## Toro Workman Cab Update Kit 108-7030

4-14905

Update detailed request list, Dec. 28, 2004.

Figure 1

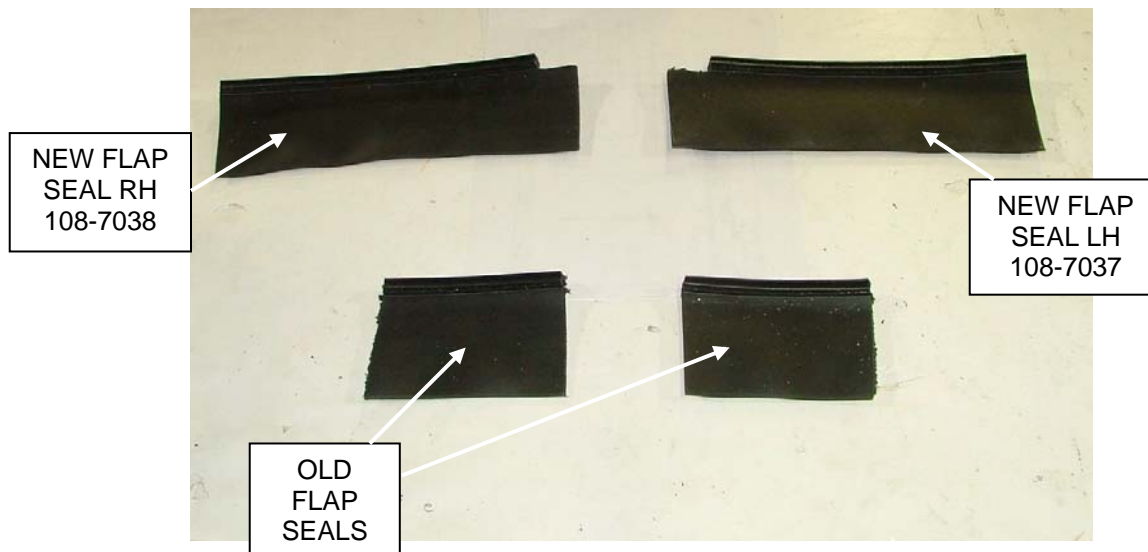
1. In the mount kit box; Rear seal flaps -change out the short seal flaps with the long seal flaps.  
See Figure 1.

**Figure 4a**

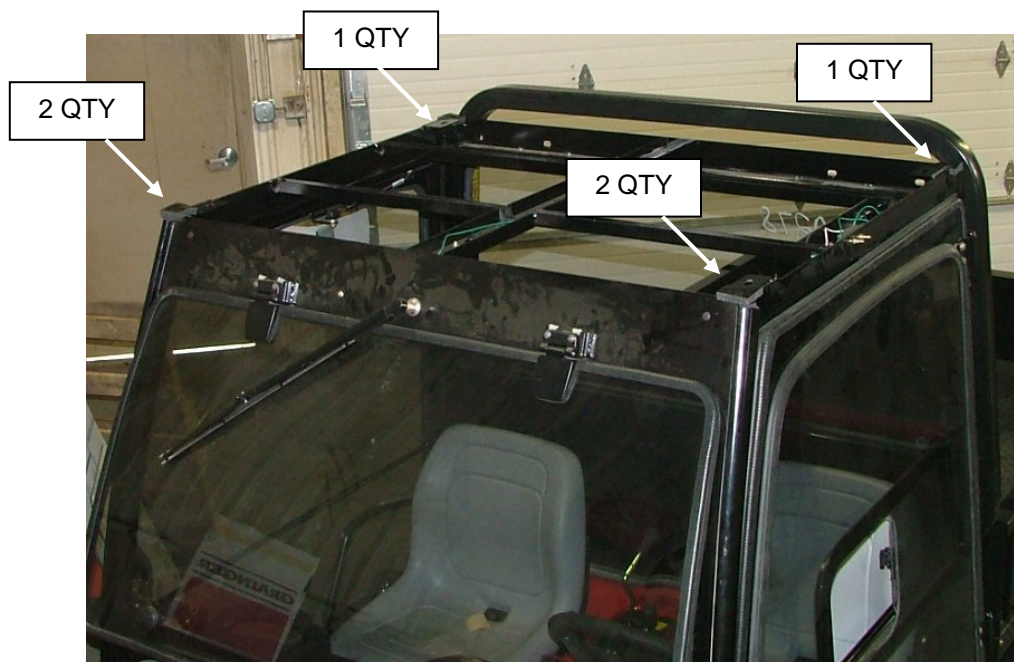
4. Install profile corner seal pads ( $\frac{1}{2}$ " x 2 x 2) Part No. 108-7031. Install (4) Qty in front, (2) Qty in rear. See Figures 4a, 4b and 4c.
